**Report to the Future Melbourne (Planning) Committee**

**Planning Permit Application: TP-2017-931/A  
407-415 King Street, West Melbourne**

**3 December 2019**

**DELEGATE REPORT****APPLICATION TO AMEND A PLANNING PERMIT**

Figure 3: Proposed section plan. The red dashed horizontal line denotes the approved building height. The red circle denotes the parapet of the facade and the extents of the lift overrun which is proposed above the approved building height.

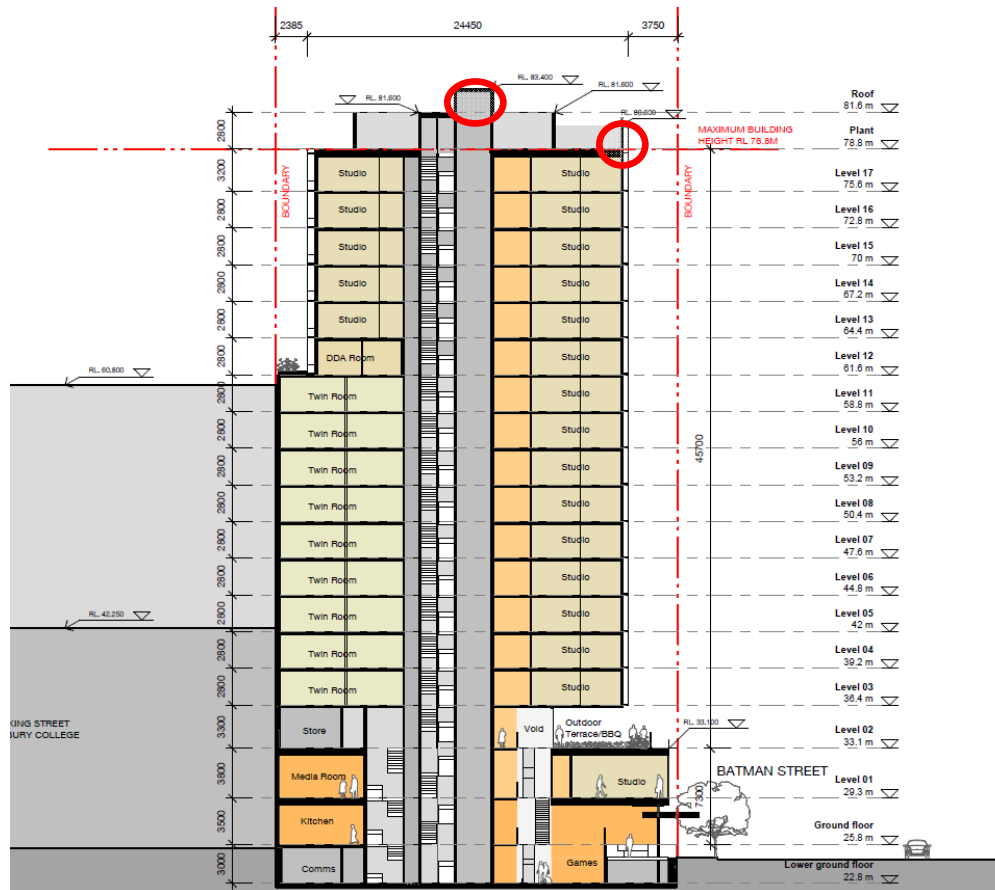
As depicted in figure 3 above, the high parapets have been proposed on the Batman and King Streets façades. The high parapet will sit 2.8m above the approved façade height and will act as a 'capping' to the architectural expression of the proposed building. This high parapet does not form an additional level to the building. Both Council's Urban Design team and Heritage Advisor are of the view that this is a successful approach as it enhances the architectural expression of the building.

The proposed lift overrun will be constructed 1.8m higher than the previous approved lift overrun. As depicted in figure 3 above, the lift overrun is well setback from the title boundaries and will occupy only a small area of the roof level. The lift overrun will not be visible from the public realm and therefore is considered to have a negligible impact on the overall height of the tower.

Figure 8: Proposed floor plan showing the twin rooms on the west boundary and the studios with windows setback 2.9m from the southern boundary.

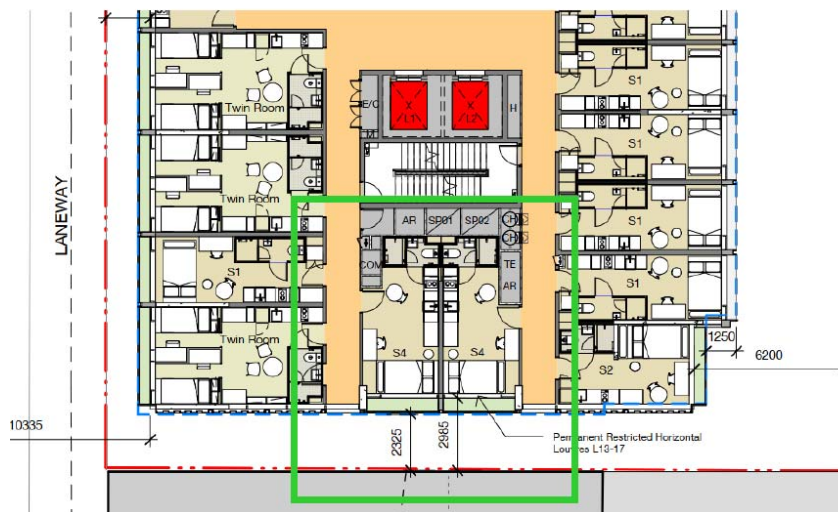
Council's Urban Design Team remained concerned with the daylight access to the kitchen / dining area of the twin rooms located on the western boundary. Refer to figure 9 below.

It is noted that this type of configuration is unavoidable on a site of such a shape and with heritage constraints. Nevertheless, as depicted in figure 9 above, these rooms will continue to receive daylight and natural ventilation. In addition, these rooms are associated with student accommodation. While a reasonable level of internal amenity should be provided, the same cannot be expected as would be required in a dwelling.

It is noted that from levels 12 to 17 the proposed studios on the southern boundary will have windows which are setback 2.9m from the title boundary. These windows are the only source of daylight and outlook to these studios. Refer to figure 8 below. Should the adjoining site be redeveloped, it will be expected that any development be constructed with a similar setback resulting in a total separation of approximately 6m. As these rooms are not the primary place of amenity for the students i.e. there are

internal and external communal spaces, this is considered acceptable as there will still be adequate daylight and ventilation to these rooms.

Figure 9: Details of proposed louvres to address overlooking.

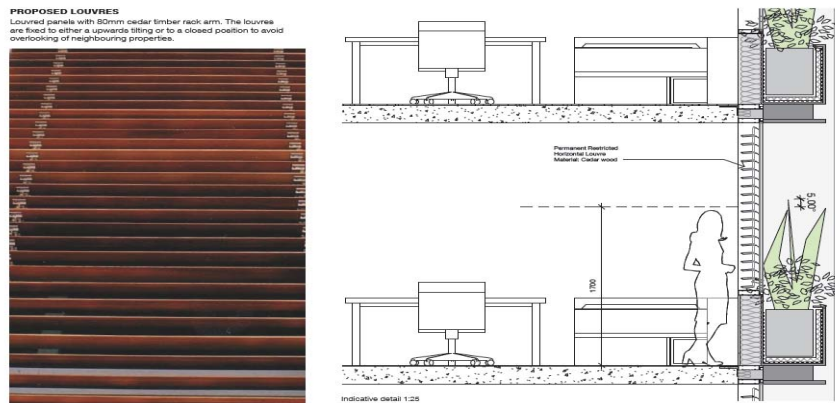
Condition 1c of the current Planning Permit TP-2017-931 requires screening to be provided to the windows on the western elevation to prevent overlooking into the habitable room windows and balconies of the dwellings at 15 Batman Street that are within a distance of 9 metres to demonstrate compliance with Standard B22 to Clause 54.04-6 of the Melbourne Planning Scheme.

The proposed development seeks to construct screening in the form of louvres from ground to level 4. Details of the louvres are provided in figure 10 below. The louvres comply with the requirements of the condition. Above level 4, there is no potential for overlooking as there is a minimum separation of 9m between the habitable room windows / balconies of the neighbouring dwellings to the proposed rooms. This is depicted in figure 9 below.

Figure 11: Proposed overlooking diagram demonstrating how proposed screening prevents overlooking into the rooftop terrace of 383 King Street.

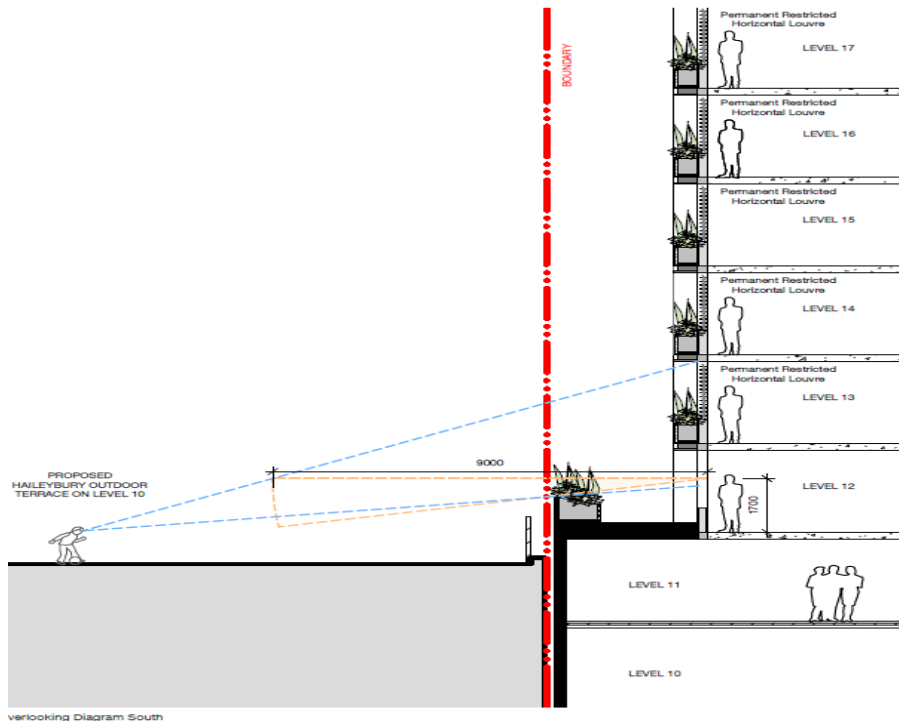
It is noted that there is no potential for overlooking to occur from level 12 of the proposed building to the roof terrace of Haileybury College as these levels will be constructed to a similar floor level and there are balustrade and planter boxes screening between the two levels. Refer to figure 11 below.
